SEWAGE DISPOSAL TESTING

MARYLAND STATE DEPARTMENT OF HEALTH

ROAD AND DESCRIPTION 14831 Triadelphia Rd., Glenelg, Md. (SAPLING RANCH)

"Sapling Range" the residence of
Dr. & Mrs. C. Robert Goshen 14831 Triadelphia Rd.
Box 60, Glenelg Maryland, 21737
scale 1"=100'

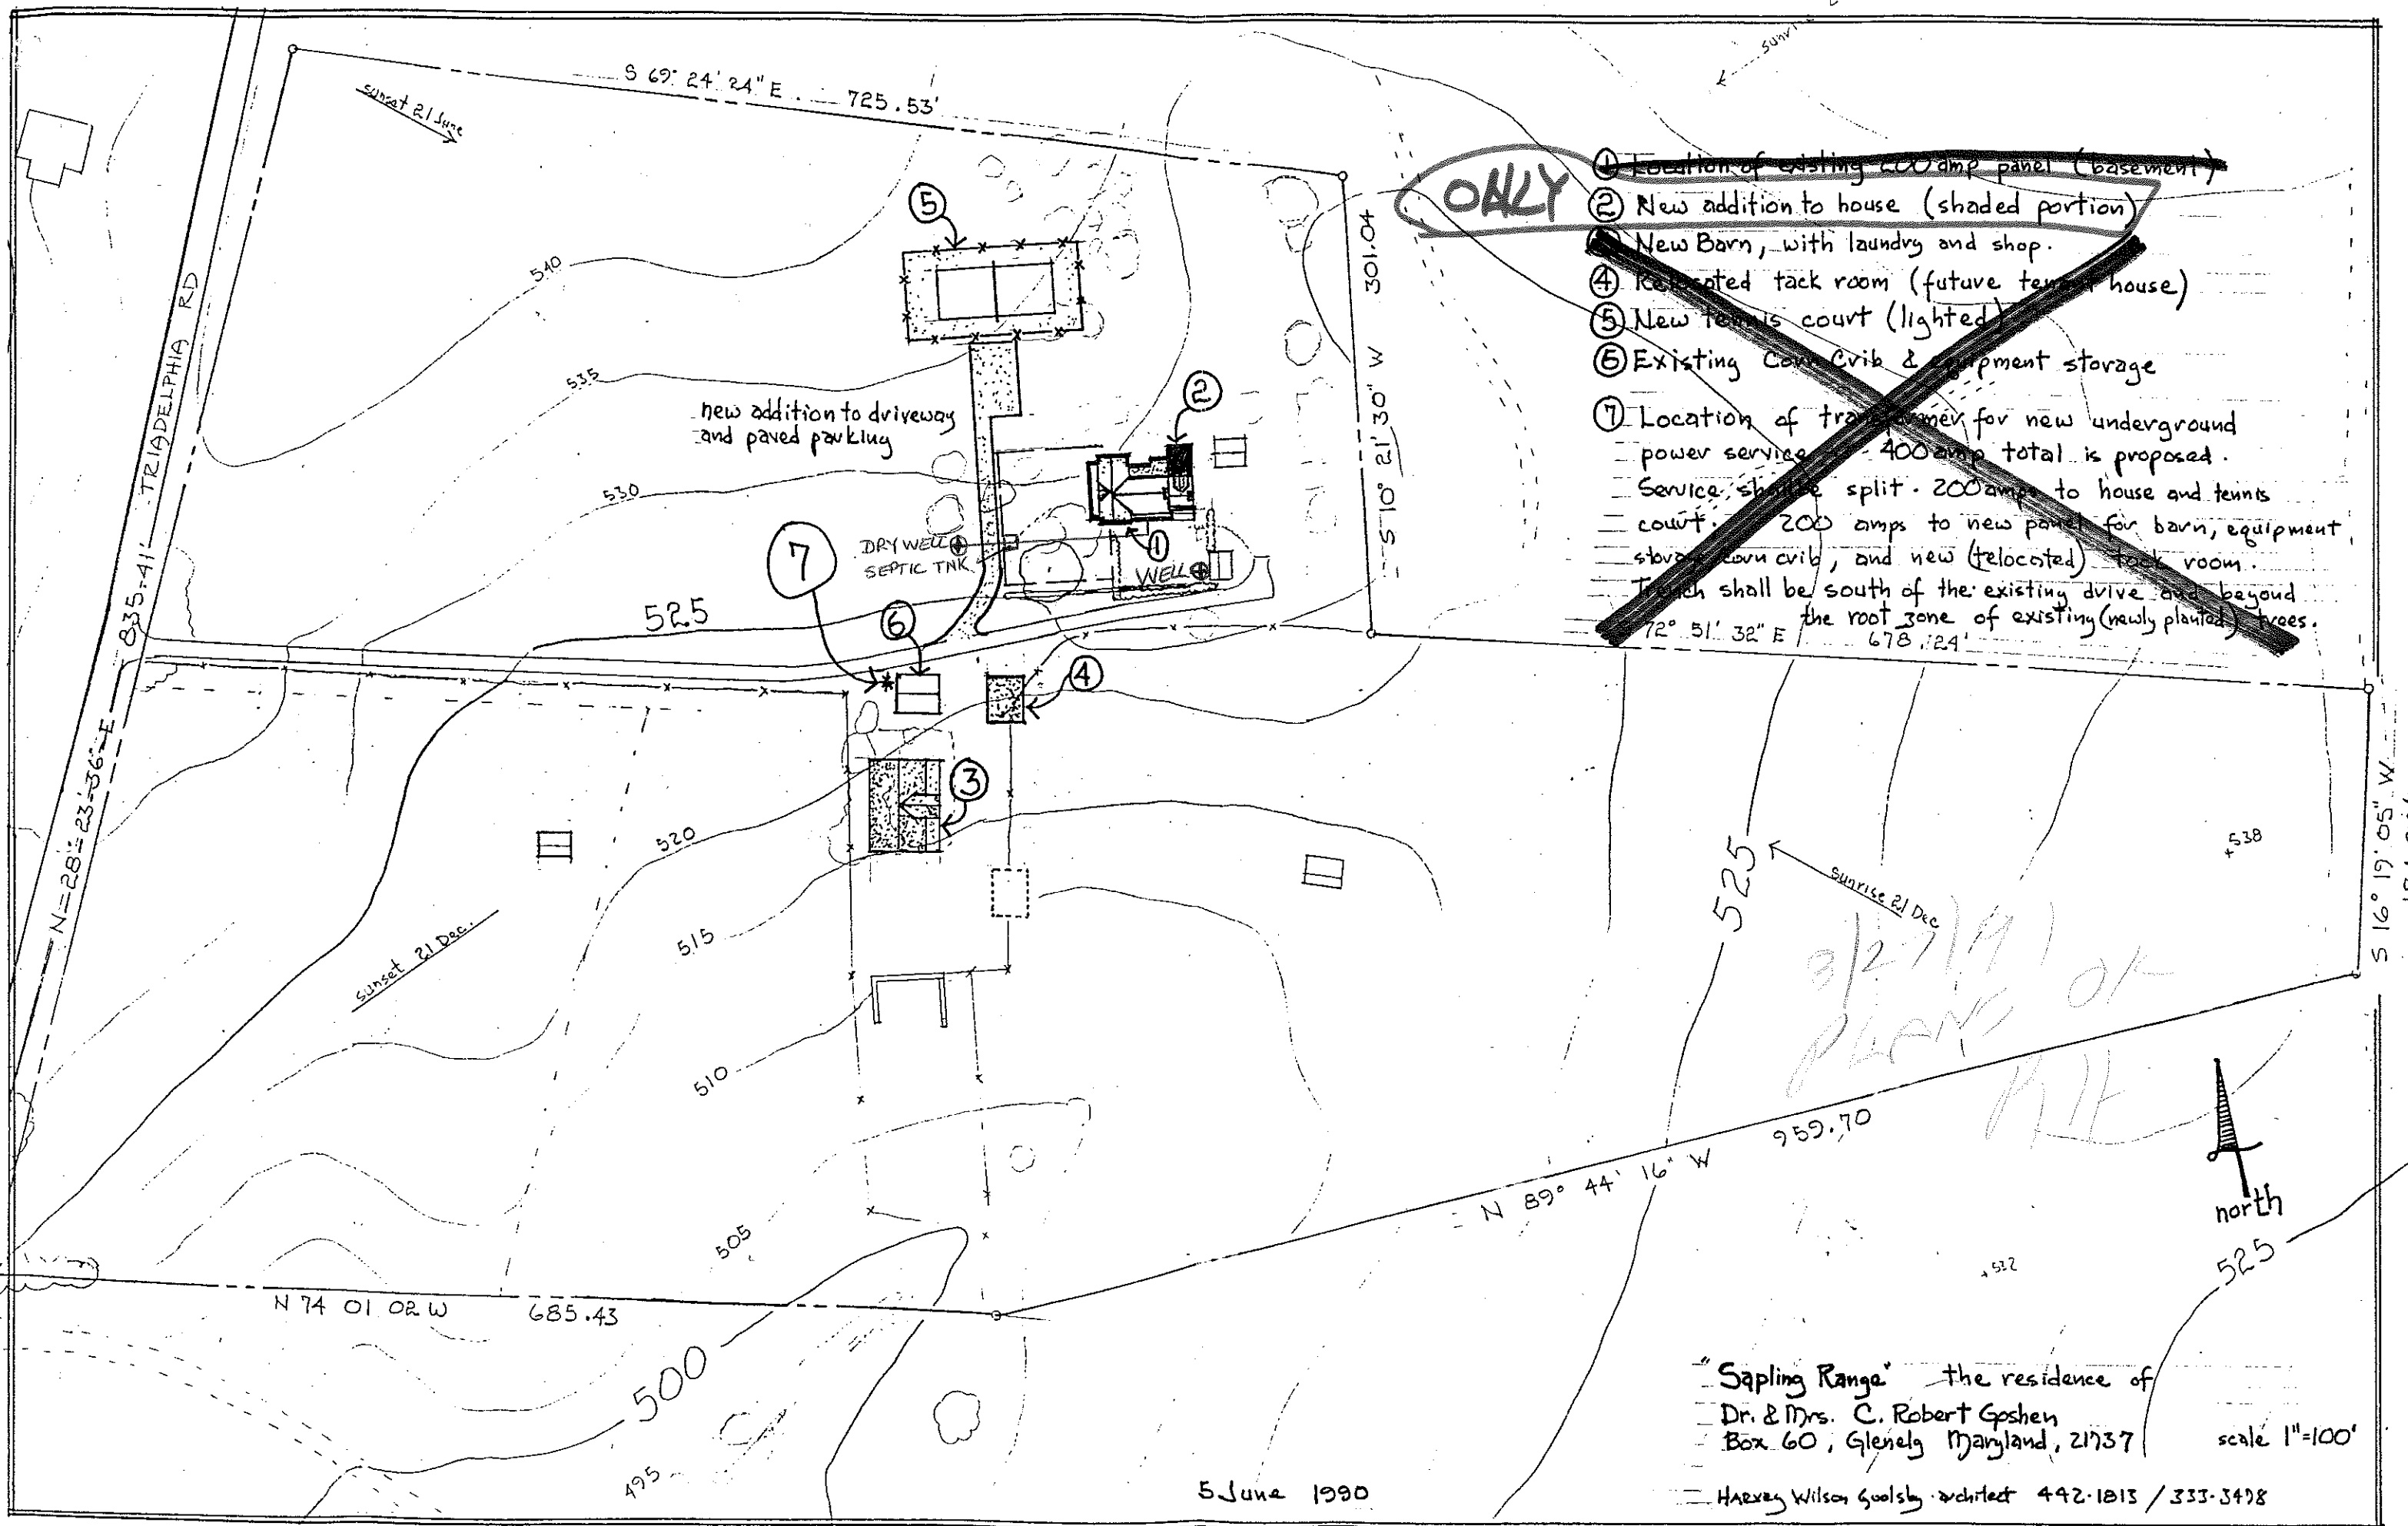
Approved: For Private Water
+ Private Sewerage Systems
Howard County Health Dept.
John Boyle 12-490
IN Accordance With Office Note

GOSHEN. PROP-OWNER'S PREFERENCES

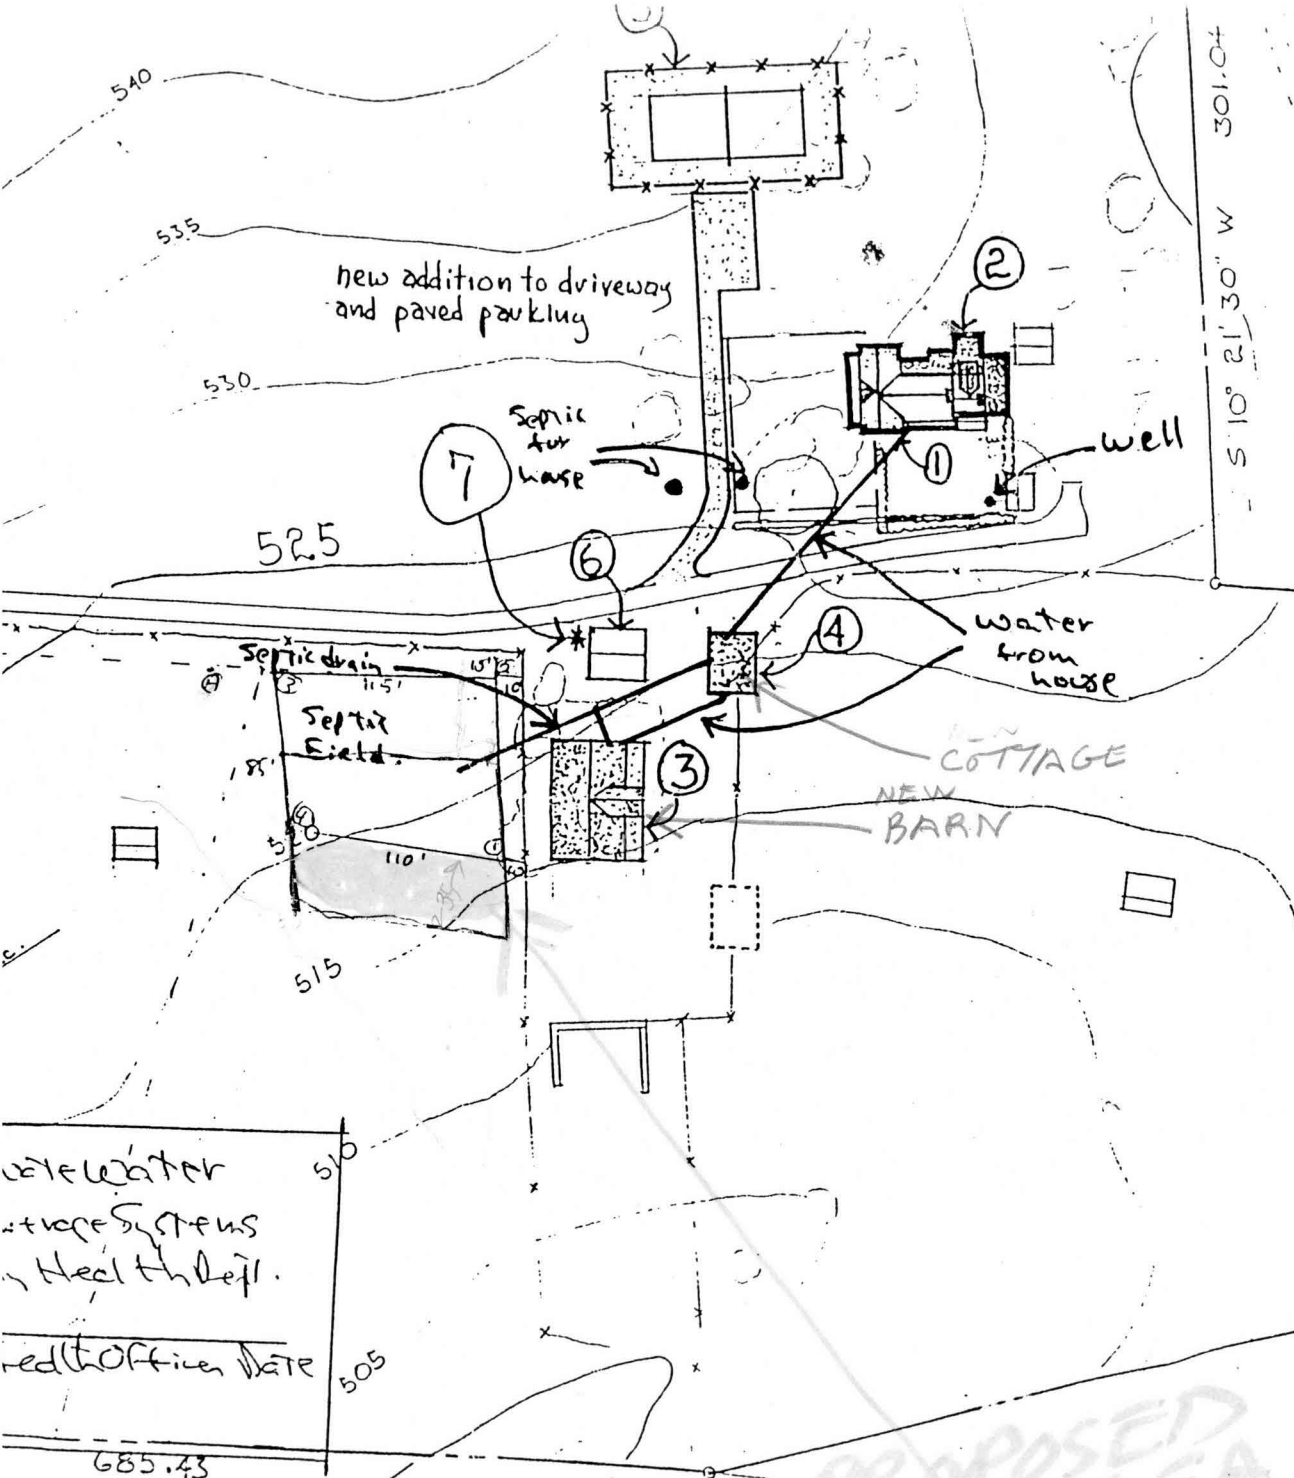
- 1- Combine Bork Barn & Cottage into one septic system. If this can be done can we move perk area down 40 FT.
- 2 - If two systems required can amount or size of trenches be reduced down to one trench? (100' long)

1/16/91. HOUSE REQUIRES SEPARATE 10,000 ~~GA~~ EASEMENT
AND SEPTIC SYSTEM.

BARN REQUIRES OWN EASEMENT & SYSTEM AS WELL.
IF STANDARD EASEMENT & SYSTEM IS
CONSIDERED NOT REASONABLE, DOWNSIZING CAN
BE CONSIDERED.

INSTALLER WILL HAVE OWNER ARRANGE
FOR MEETING IN OFFICE TO DISCUSS.
